MILITARY INSTALLATION DEVELOPMENT AUTHORITY
Design Review Committee Meeting
November 18, 2025

STAFF REPORT

Project: Deer Crest Village Parcel 3 Townhomes Site Plan

C306

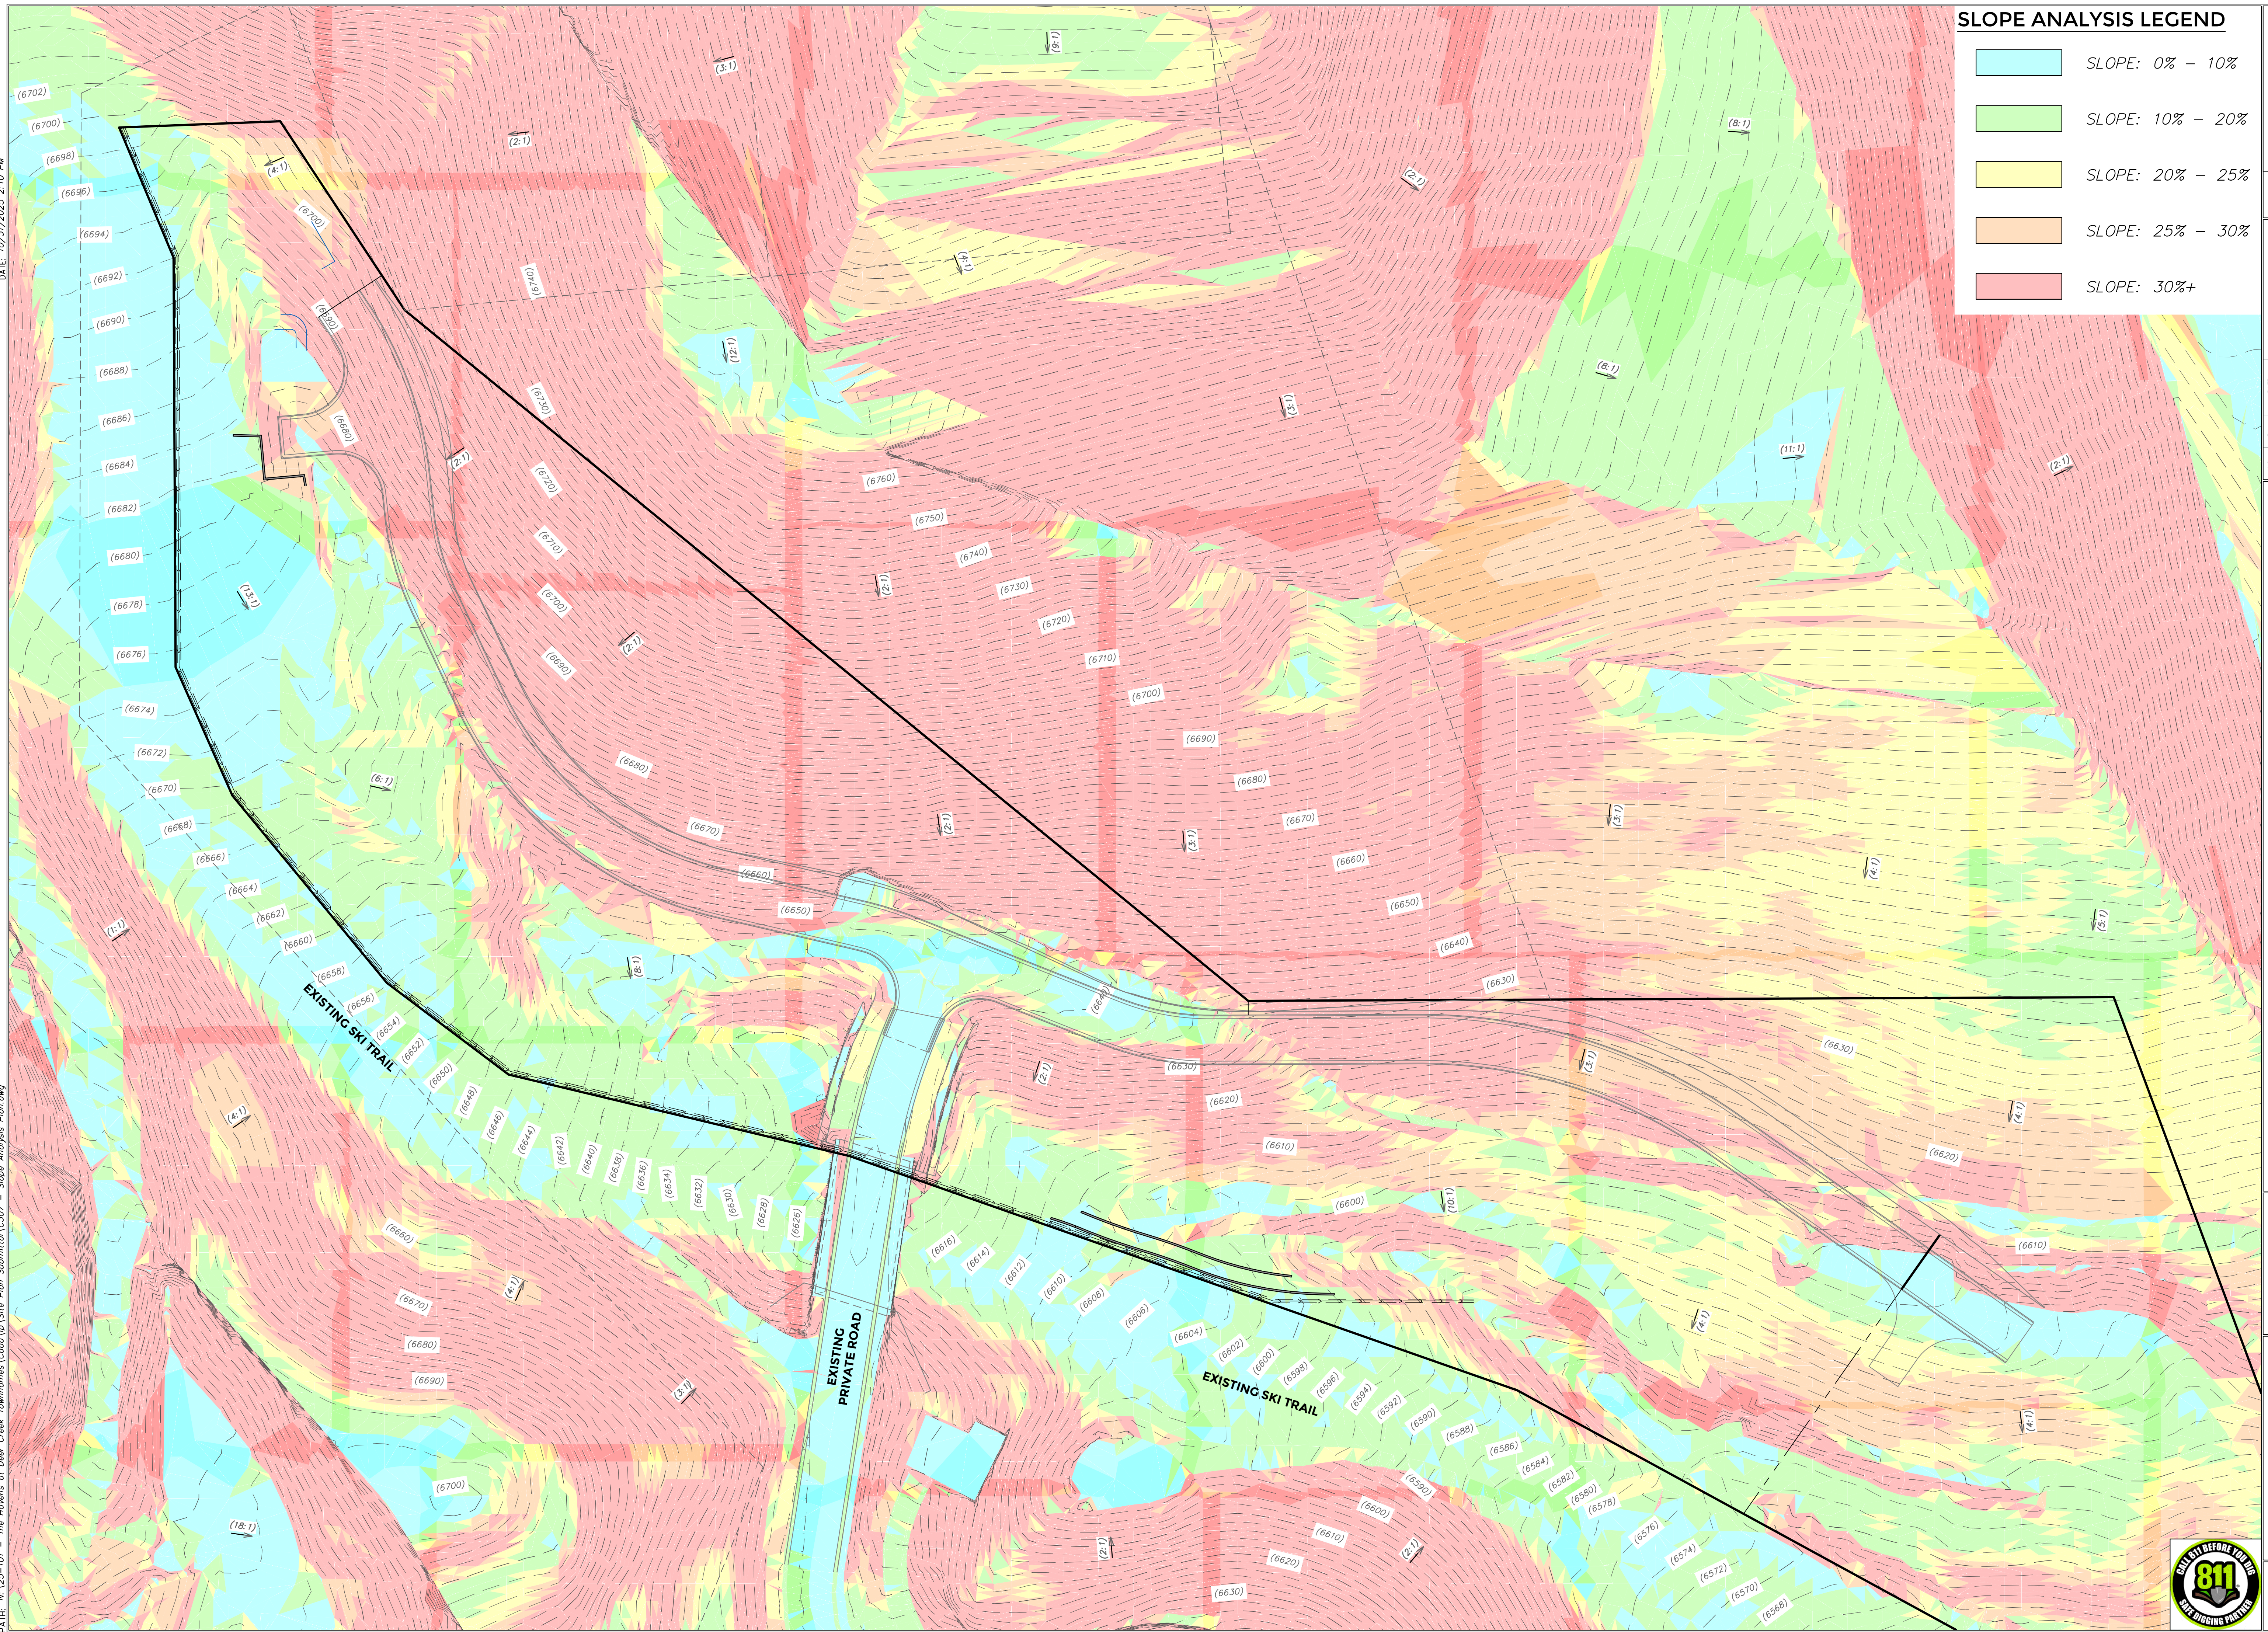
2.01.B.1.i – Slope Data: C301. There are areas of proposed development that are shown on slopes exceeding 30%. MIDA's Development Standards and Guidelines do not prohibit development on slopes greater than 30%, but MIDA Staff does acknowledge this and points out to the Applicant that development on such slopes will require significant earthwork, walls, and cost and will have significant impact on topography and existing vegetation.
